**North State Water Alliance (NSWA) Comments on
Cal WaterFix and RDEIR/SDEIS
Exhibits A-D
October 30, 2015**

**List of Commenting Parties
Cal WaterFix and RDEIR/SDEIS
October 30, 2015**

Report on Review of Bay Delta Conservation Program Modeling

Figure 1. Diagram of the north Delta depicting areas where increased juvenile salmon mortality is anticipated if the “WaterFix” Alternative 4A was implemented.

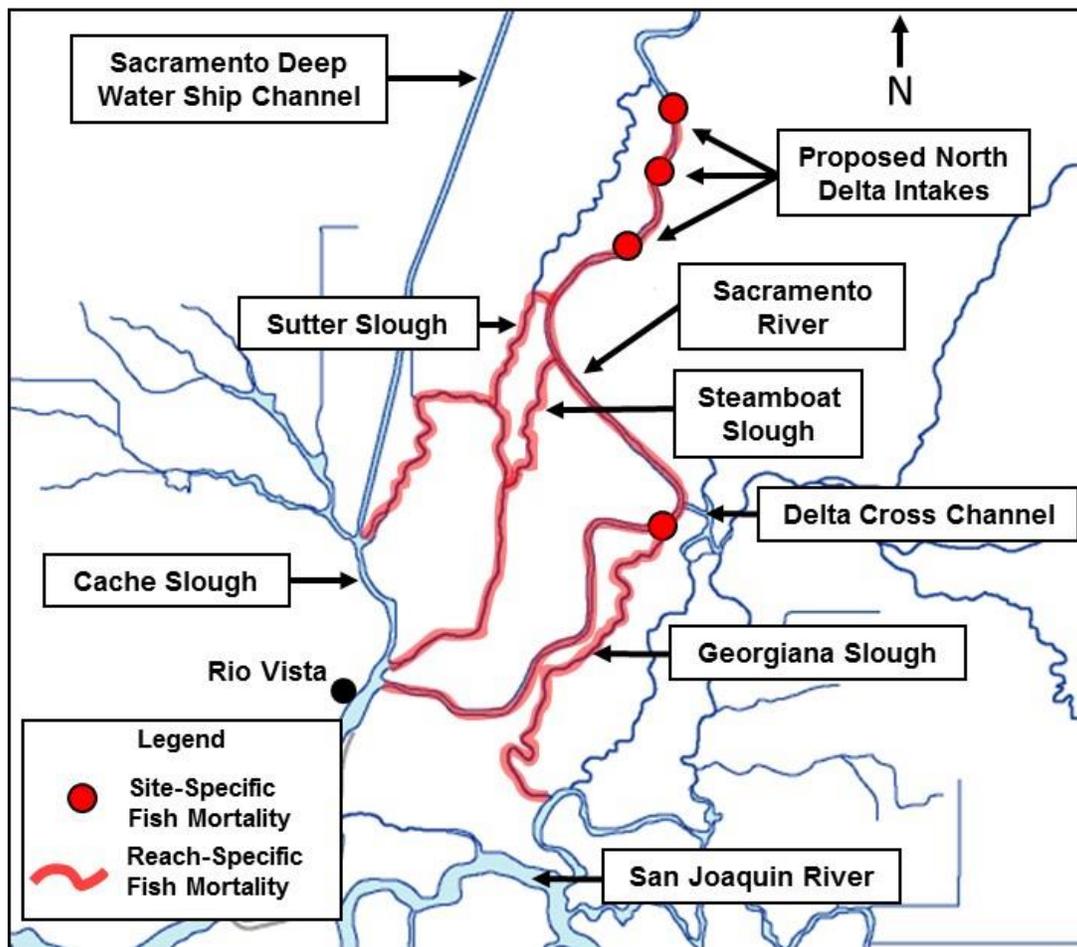
Figure 1 below provides a conceptual depiction of this problem. Site-specific mortality (red dots in Figure 1) of salmon is anticipated at each of the three water diversion intakes and at the non-physical barrier at the Georgiana Slough flow split. Increased reach-specific mortality (red lines in Figure 1) is anticipated downstream of the three diversion intakes because of problems caused by reduced flows compared to baseline conditions. No change in mortality is anticipated to be caused by the Delta Cross Channel gate operations because it is assumed that the gates would be closed during the period when the three north Delta diversions would operate. Also, it is assumed that changes in salmon mortality in Cache Slough, the lower Sacramento River downstream of Cache Slough, the lower Mokelumne River, and San Joaquin River would not be measureable because of the extremely large tidal influence in these regions.
